# South Industrial Zone

Environmental Statement  
July 2020

Appendices to Chapter F  
(Air Quality)

## **Appendix F3: Consultation records**

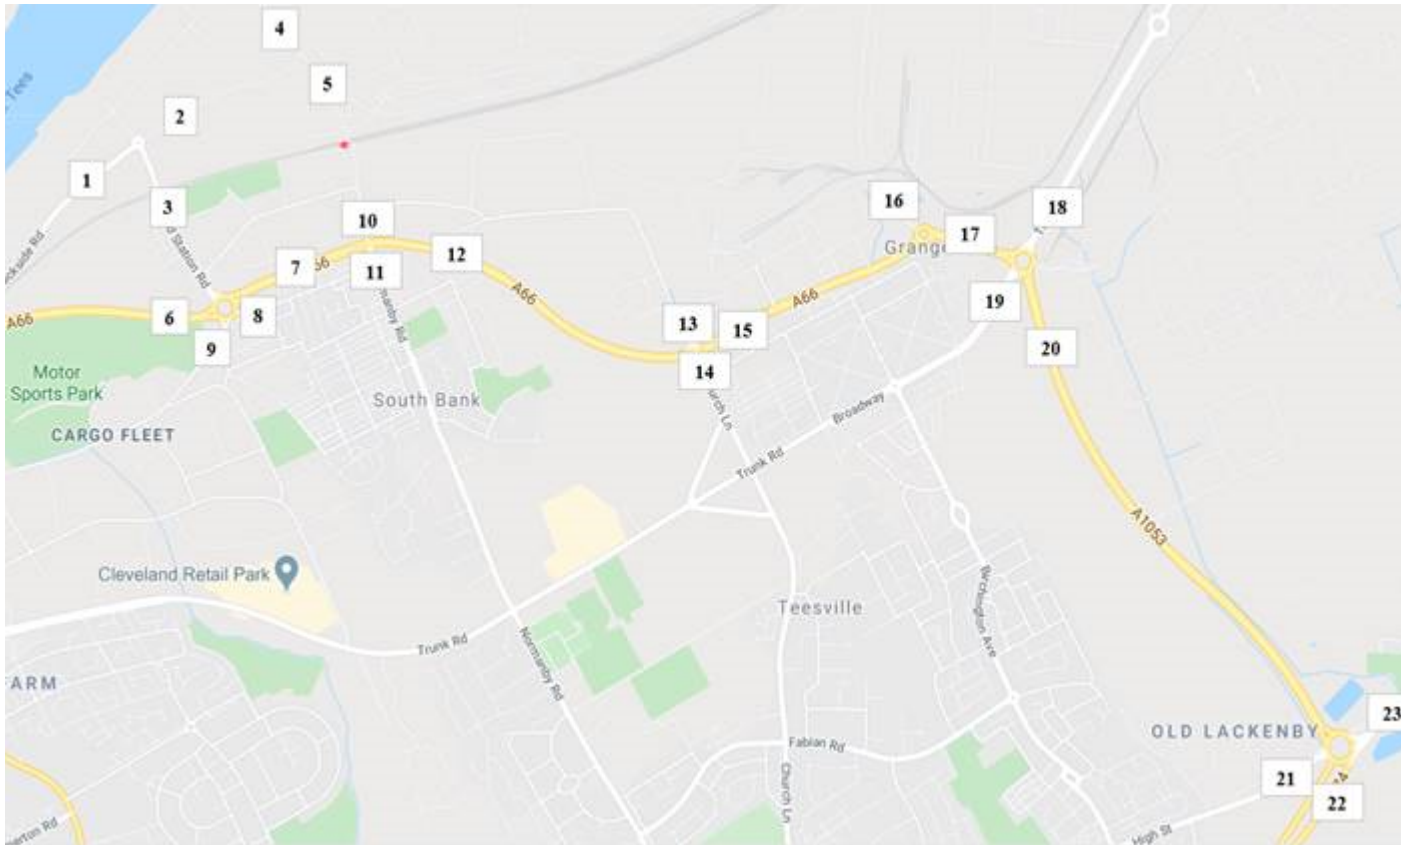
I will follow up on all of the air quality points you raise below shortly, but the main point that stands out to me is about the extent of the traffic assessment. I have included a screenshot below from my transport colleagues – this is the full extent of their model. They have confirmed that there is no other data available to me. I hope this is sufficient to cover the requested area: “consider traffic along the A66 through Middlesbrough and the southbank area of RCBC” but if you could let us know your thoughts as soon as possible, that would be great so that we can commence with our assessment.

Note that point 6 goes up to the A66 junction with Cargo Fleet Lane (North Ormesby) only.

We have a joint DPH covering both RCBC and MBC, and are currently in the development stage of joint AQ strategy; therefore a joined up approach to the area would be required for the assessment to ensure there will be no negative impact from the development across both authorities. – Recently, Middlesbrough did a lot of work with DEFRA on LEZ for the flyover circled below ( M’bro were able to show that the area did not require LEZ) however I think it would be remiss of us on such a large application to not consider this.

Could you consider M’bro traffic data? or can you be clear that point 6 would cover the traffic coming into the Redcar Cleveland Borough from Middlesbrough is sufficient?

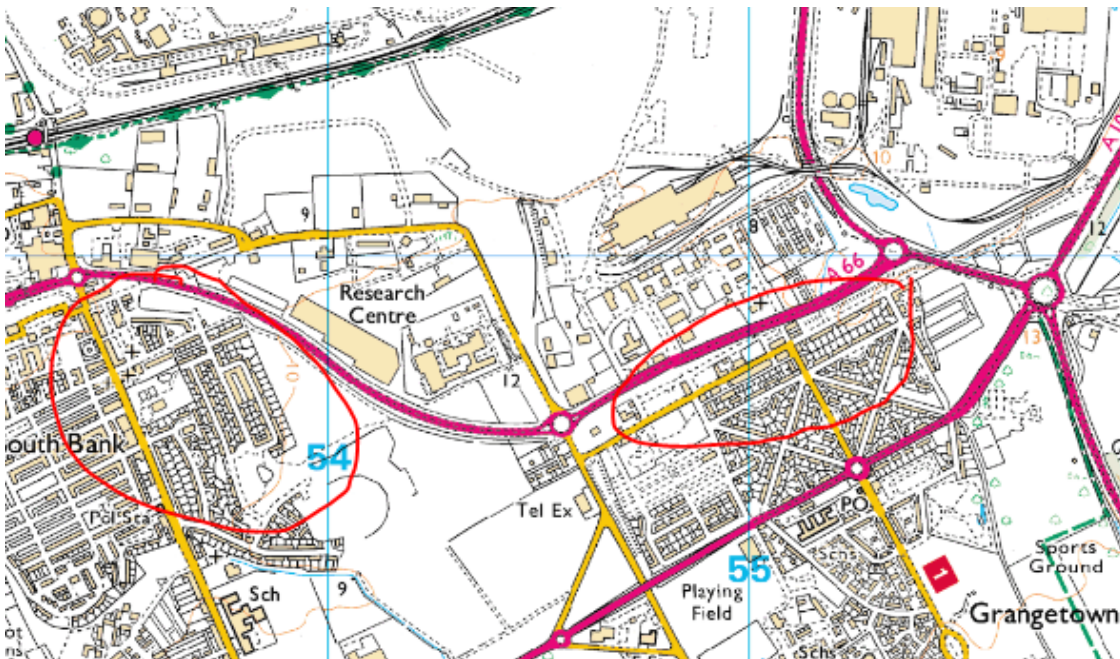
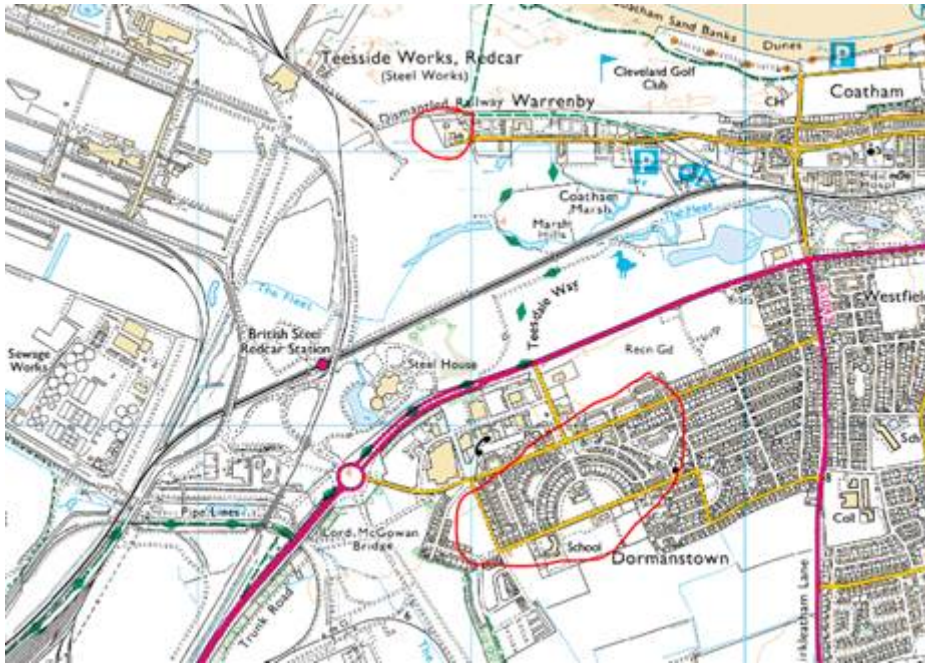
Highlighted closest residential properties circled in red below.
